NTD-NRC-94-4142
DCP/NRC0068
Docket No.: STN-52-003

SUBJECT: WESTINGHOUSE RESPONSES TO NRC REQUESTS FOR ADDITIONAL
INFORMATION ON THE AP600

NTD-NRC-94-4142
ATTACHMENT A
AP600 RAI RESPONSES
SUBMITTED MAY 19, 1994

Figure 230.59-1 - Relationships between Maximum Component Responses for X, Y, Z

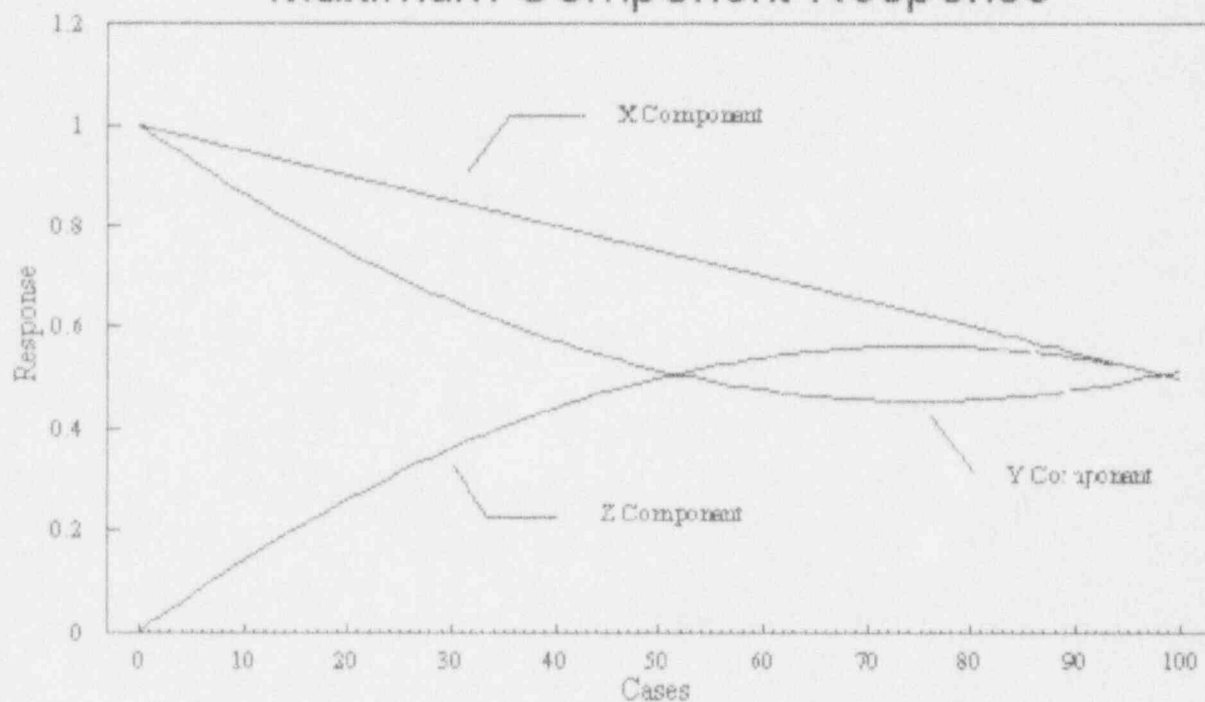
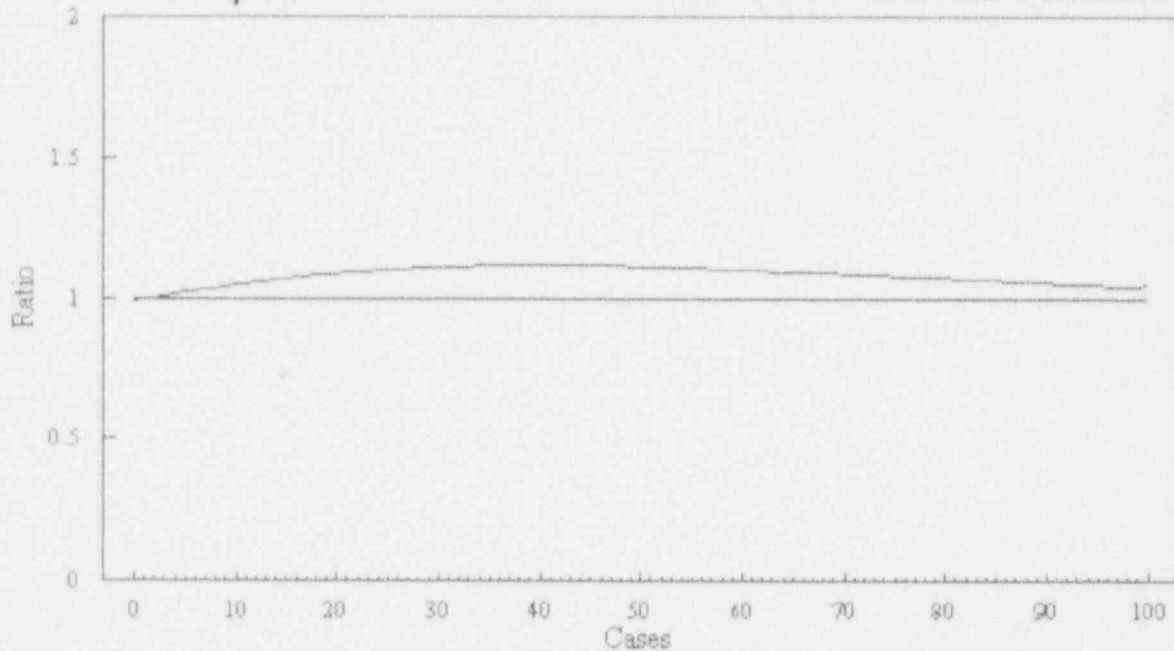
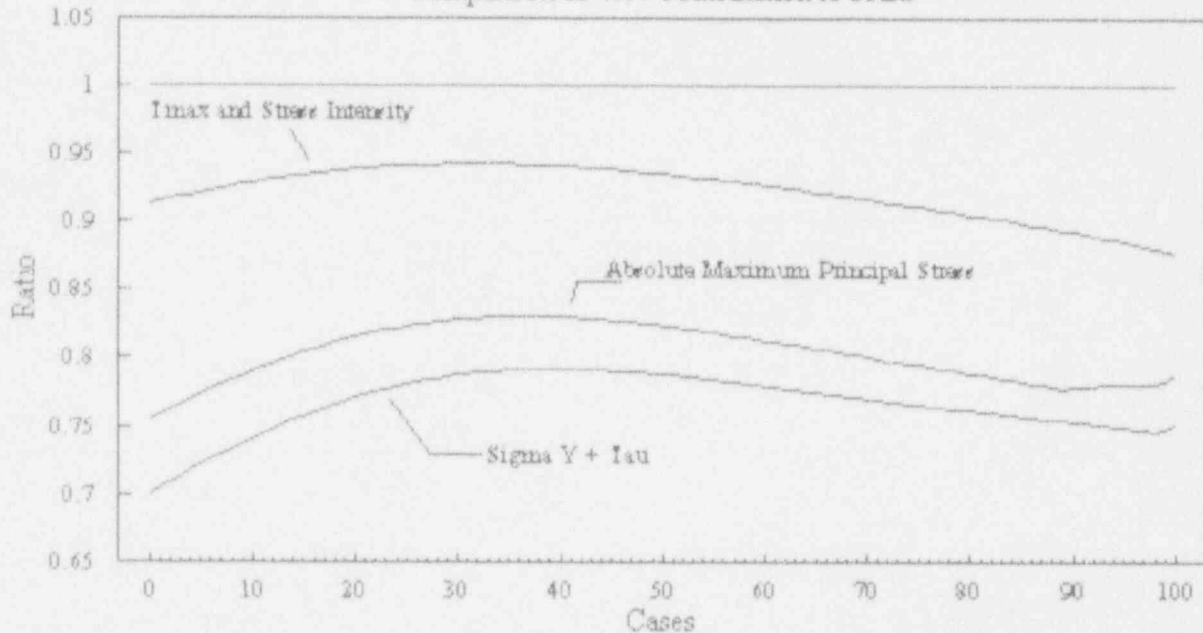
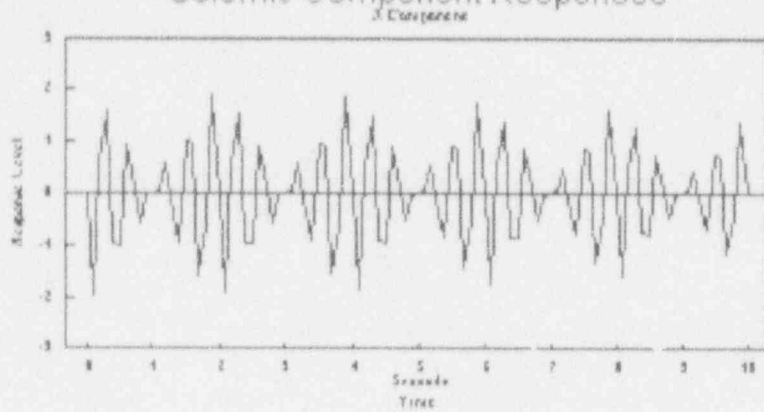
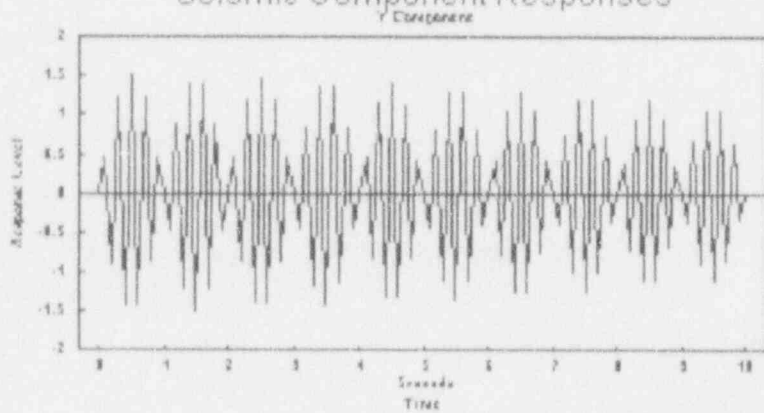
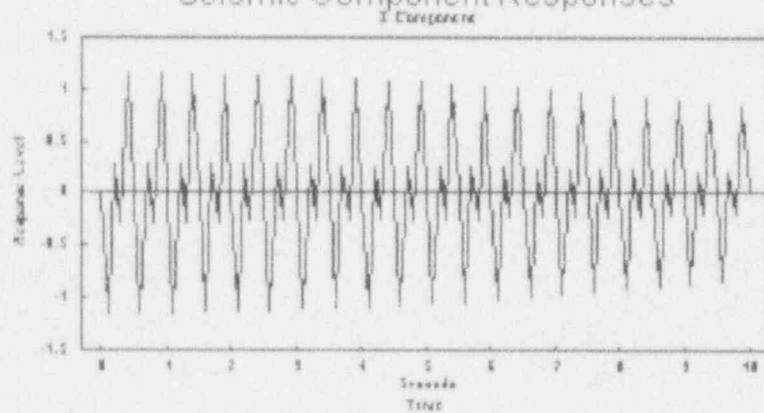
Provide, in the SSAR, a comparison between the SRSS method and the 1.0, 0.4, 0.4 method, or the bases for use of only the 1.0, 0.4, 0.4 method for the combination of seismic loads. Also Q220.67.

A representative set of co-directional responses are assumed having different relationships between these responses. Figure 230.59-1 shows these relationships for each of one hundred cases. The co-directional response for the X shock, Y shock, and Z shock have all been normalized by the maximum response. There are various cases that include two of the components of equal magnitude, three of equal magnitude, and many cases in between with one component being dominant. Figure 230.59-2 shows the formulation and results of SRSS and 40% combination methods. In only one case does the 40% combination method yield results that are lower (only 1%, 1.414 versus 1.4) than the SRSS method. This is when two of the components are equal, and the other is zero.

Principal stresses in a plate were studied along with the maximum shear stress and stress intensity. The sum of σ_Y and τ is also included in the study since it is representative of design for tangential shear. It was assumed that there was a shear stress (τ) directly proportional to the X seismic input, that one membrane stress was zero, and that the other membrane stress (σ_Y) was a combination of the Y and Z input. This would be representative of the seismic response of a shear wall or the containment vessel. The magnitudes of the X, Y and Z responses were those shown in Figure 230.59-1.

Two of the cases are shown as examples in Table 230.59-1. Case 1 has the response components X and Y equal with Z zero. Case 100 has the response components X, Y, and Z all equal. The ratio between the 40% method and the SRSS results range from 0.75 to 0.91 for the various principal stress combinations, and are 0.70 to 0.75 for the combination of σ_Y and τ . The 40% method results are lower than the SRSS methods by as much as 30%. The reason for the difference is that the SRSS method does not reflect the statistical independence of the individual co-directional responses.

as shown in Figure 230.59-4. For these time histories no attempt was made to assure that each component resulted from statistically independent motions. These time histories were considered as the component responses (X, Y, and Z) for the same examples of co-directional component response and principal stresses discussed previously. As in the first section that discussed co-directional component response cases, the maximum co-directional responses associated with the X, Y, and Z components represent the stresses as used in the respective formulations as shown on Figure 230.59-2 and 230.59-3. The results are shown in Table 230.59-2. For the co-directional resultant response, the 40% method produced results equal to 89% of the time history method and the SRSS method gave results equal to 85% of the time history method. For the principal stresses, the results obtained using the SRSS combination method are the more conservative. The results obtained for the 40% combination method are close to the time history results with the smallest result being smaller by only 12 percent. Note that these examples were selected specifically to maximize the difference between the various methods and more practical cases would not show as much difference.

In conclusion, the 40% combination method provides realistic results that are not overly conservative. The 40% method is a valid method for combining multiple directional seismic responses. This method provides a margin for those design cases involving combinations of multi-directional responses that is consistent with the margin obtained by use of the SRSS combination for a co-directional response.
